# SAN FRANCISCO PLANNING DEPARTMENT

**DATE:** July 11, 2008  
**TO:** Interested Parties  
**FROM:** Joan A. Kugler, Senior Environmental Planner  
**RE:** CASE NO. 96.281E: CENTRAL SUBWAY PROJECT (PHASE 2 OF THE THIRD STREET LIGHT RAIL PROJECT) COMMENTS AND RESPONSES

**RESPONSE TO COMMENTS**  
**VOLUME II**  
**FINAL SUPPLEMENTAL ENVIRONMENTAL IMPACT STATEMENT/  
SUPPLEMENTAL ENVIRONMENTAL IMPACT REPORT**

FIGURE 2-16

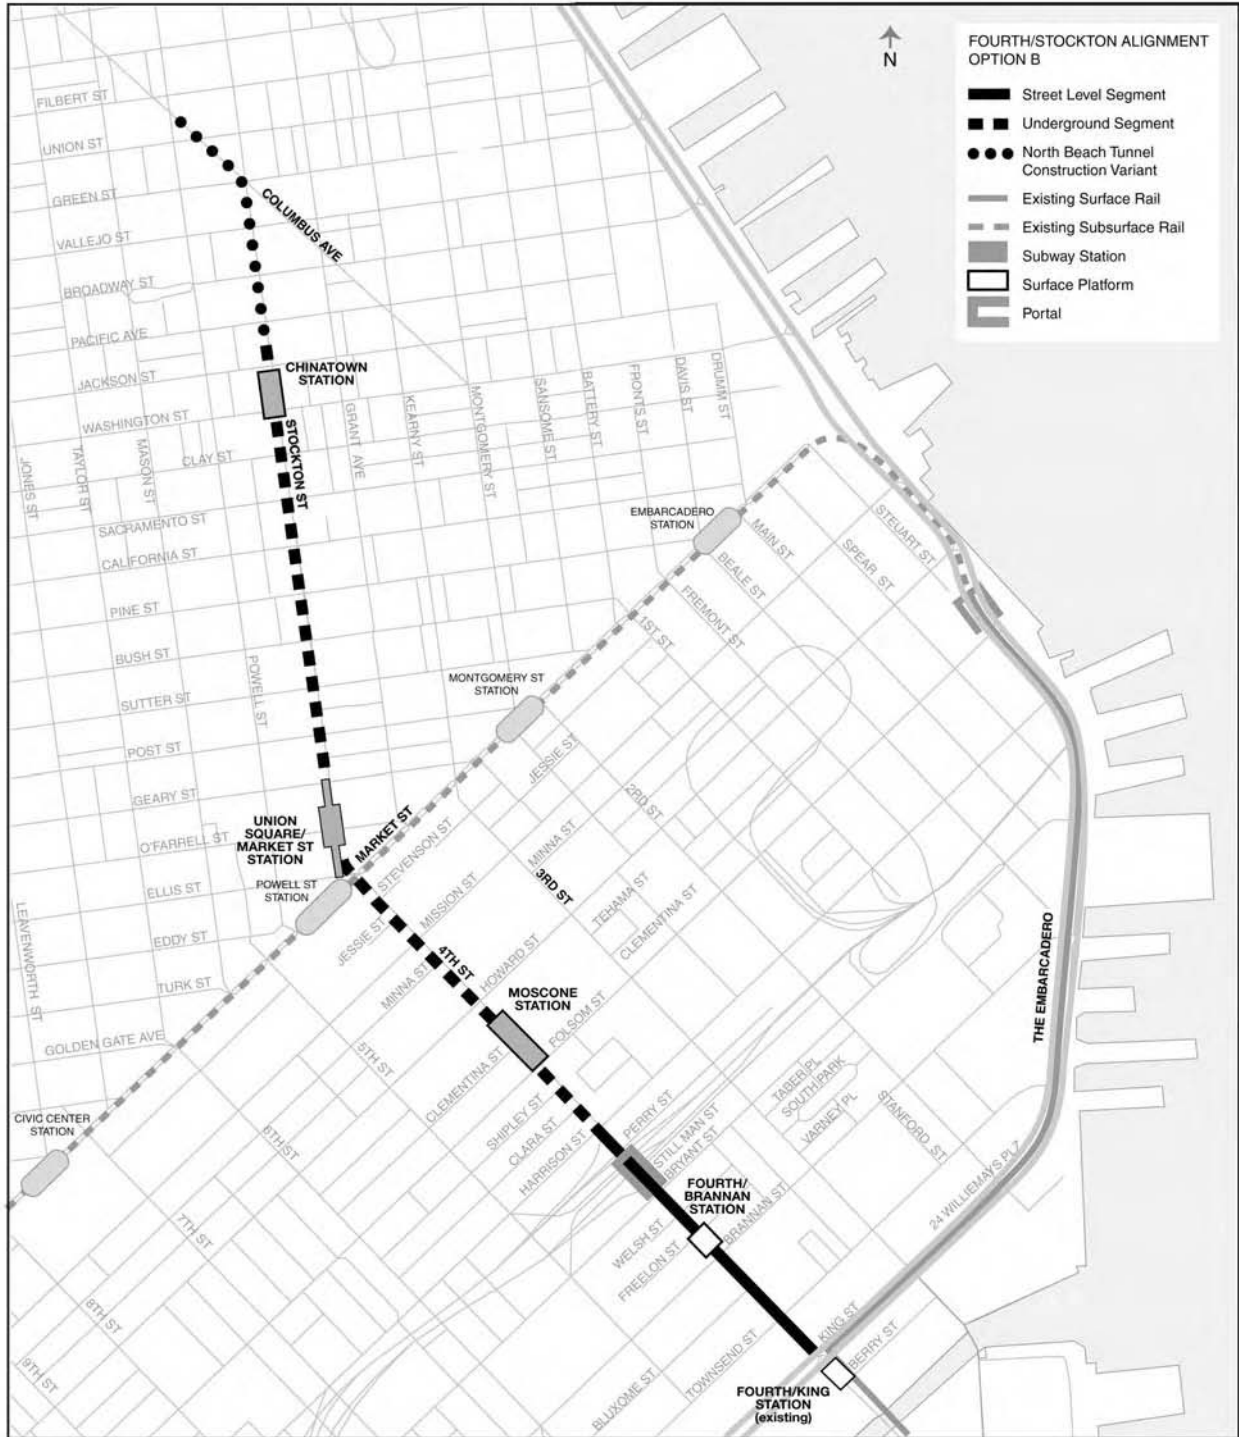
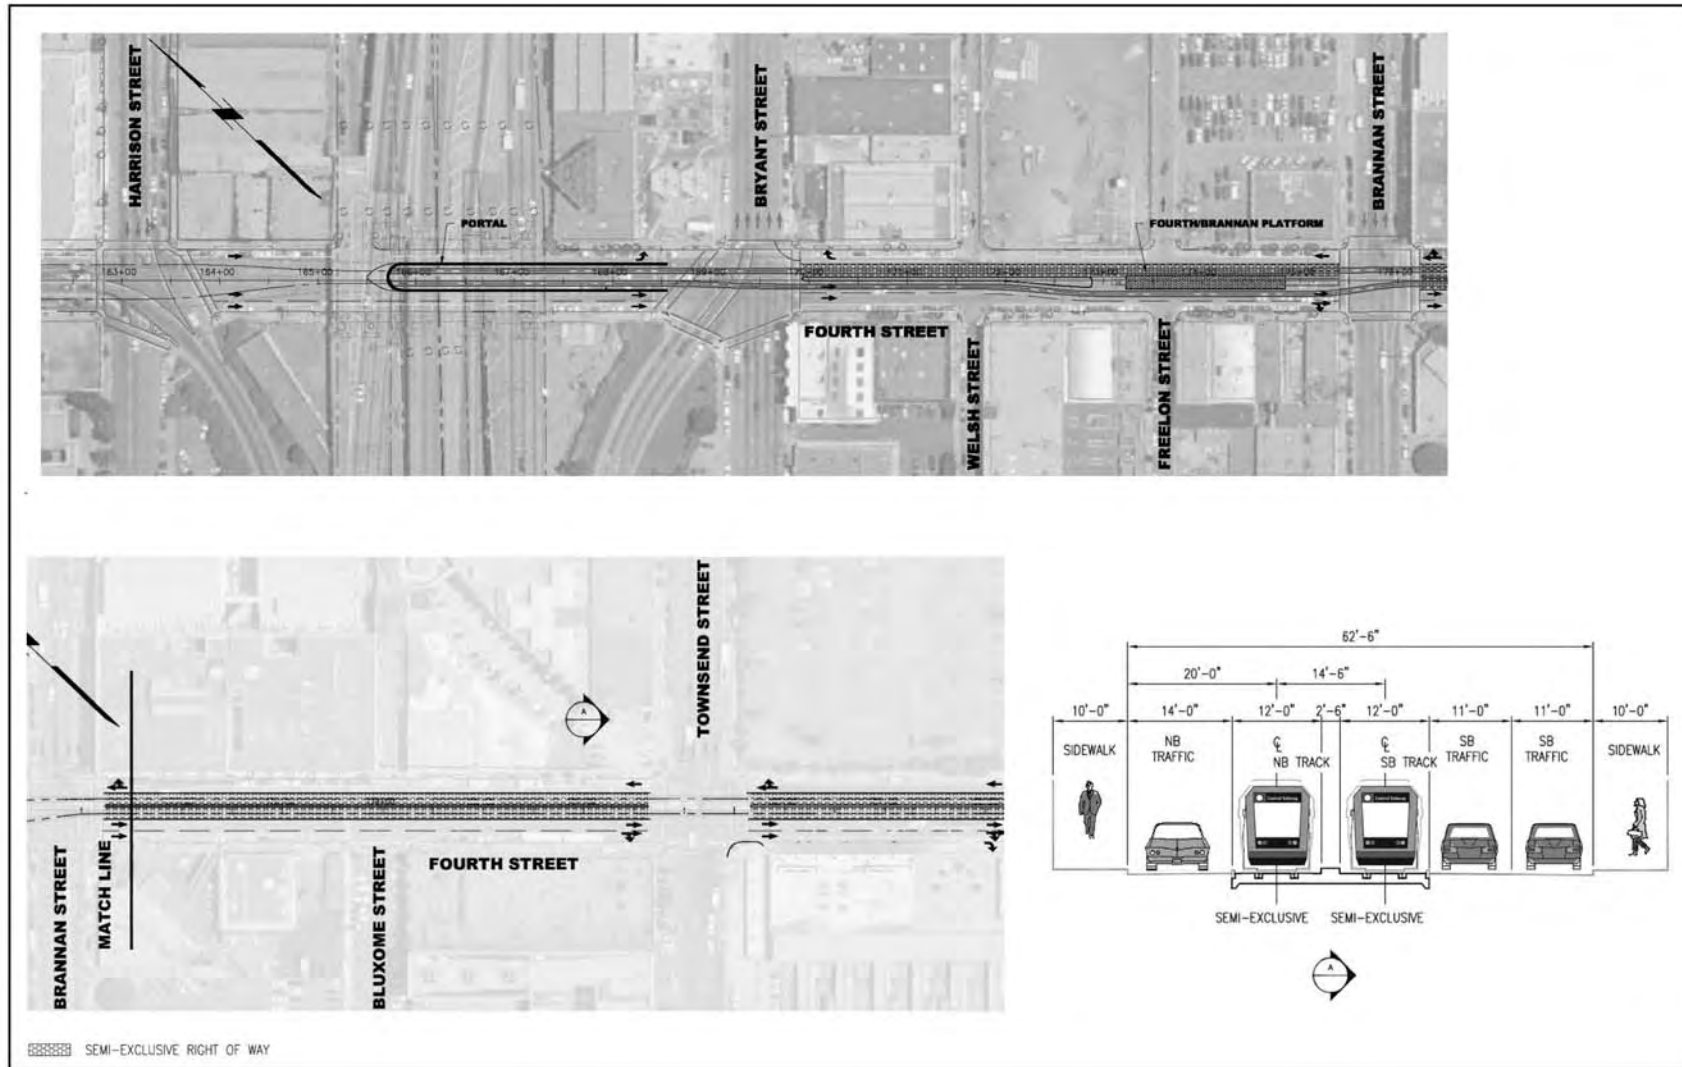
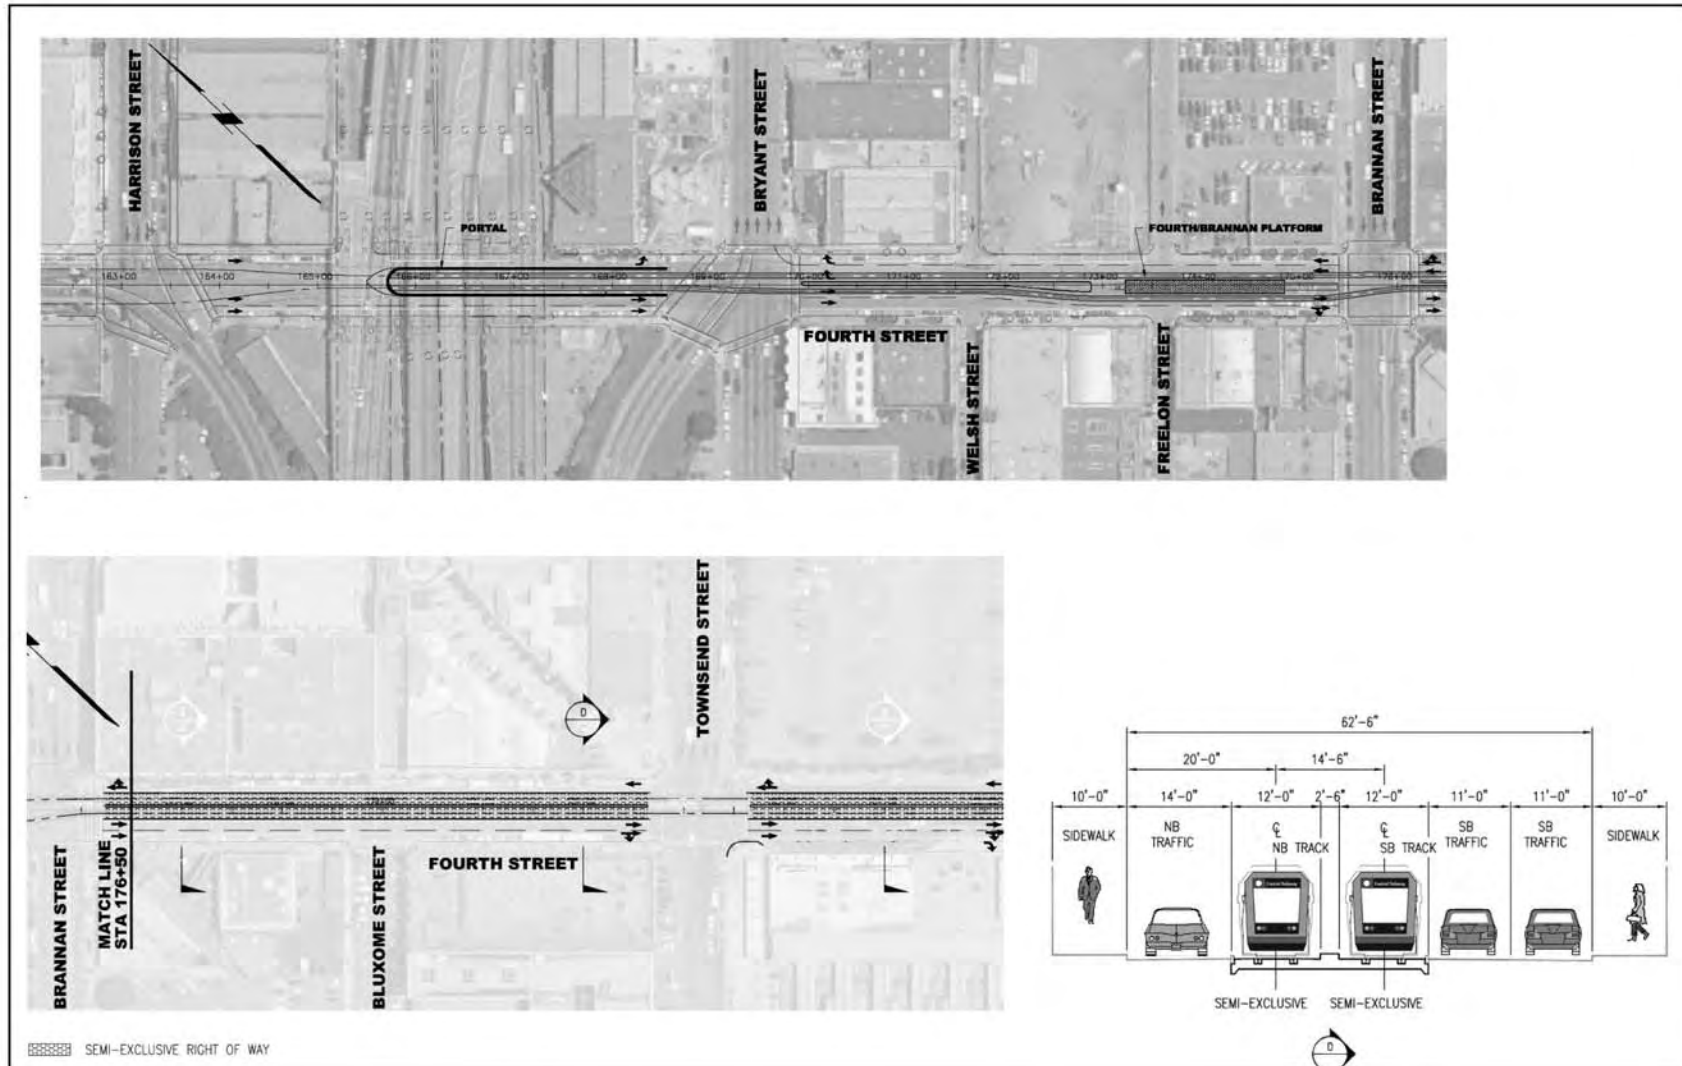
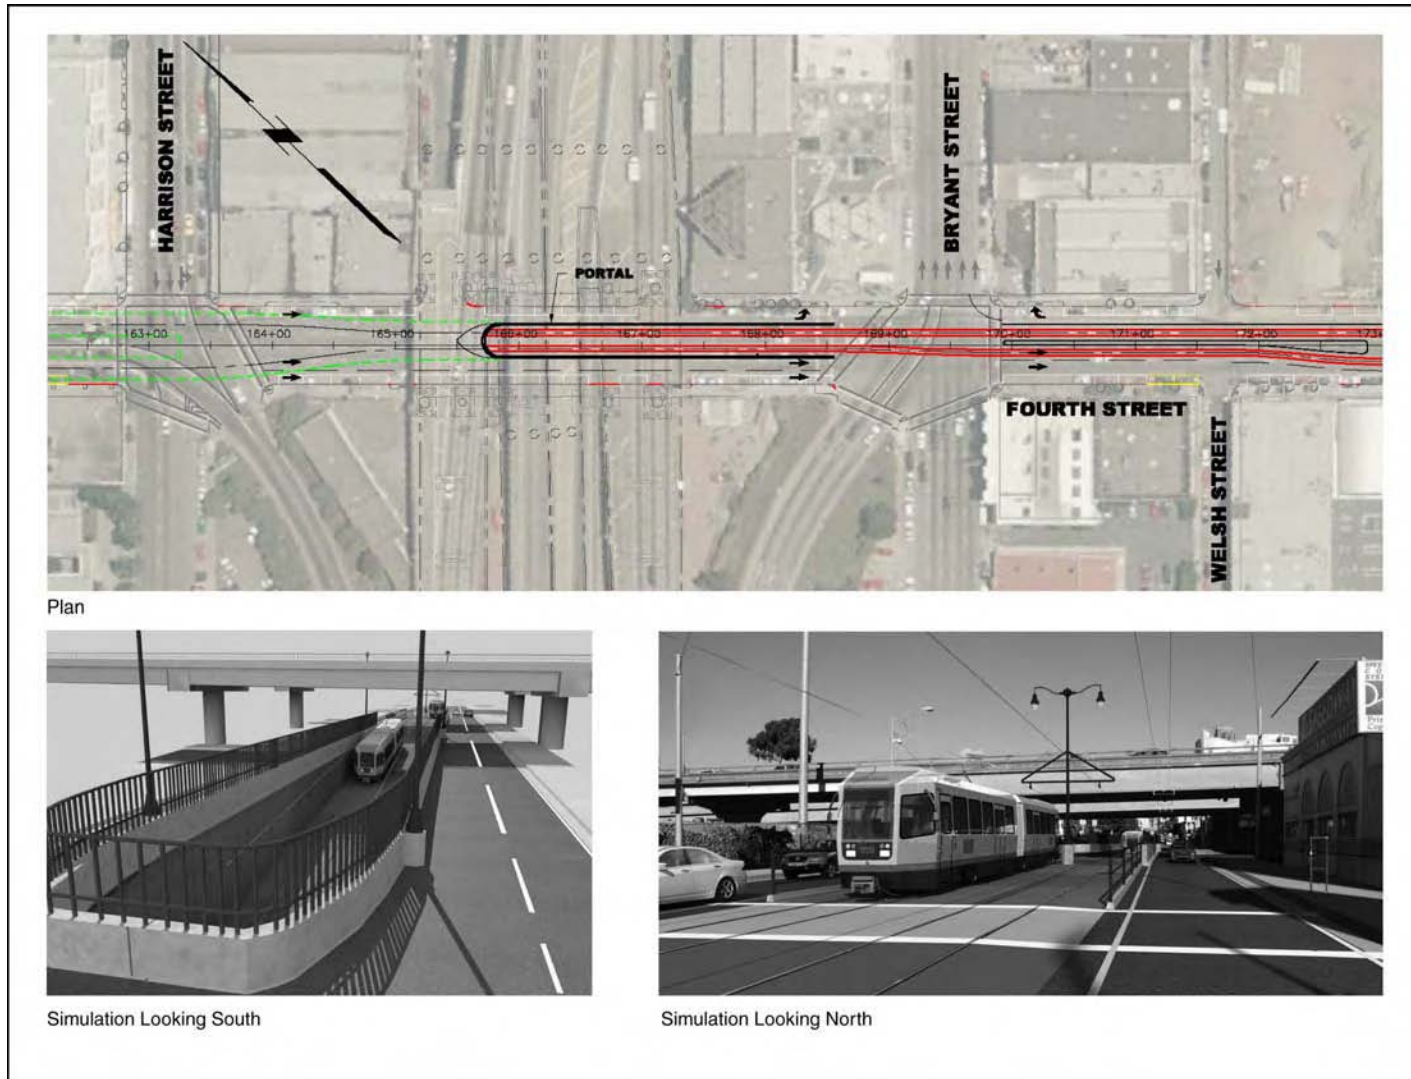
A crash barrier is planned for the portal to protect the entrance structure from turning buses. The current tunnel portal layout plans provide space for the tunnel crash barrier without interfering with the turning path of the bus as it enters the bus storage facility. Figure 2-18 on page 2-39, Figure 2-19 on page 2-41, and Figure 5-10 on page 5-40 have been revised to show the tunnel crash barrier. See Response to Comment R-1 for revised figures.

“After stopping at the station platform on Fourth at King Streets, light rail would continue north on Fourth Street to a double-track portal between ~~Bryant Perry~~ and Harrison Streets under I-80 (see Figure 2-16).”

Figures 2-16, 2-18, 2-19 and 5-10 are revised as noted in the attached pages to reflect the relocation of the subway portal and the placement of a crash barrier.

~~“Because of the location of t~~The portal on Fourth Street just south of Perry Street, under the Interstate 80 Freeway, has been located to accommodate the bus access from south-
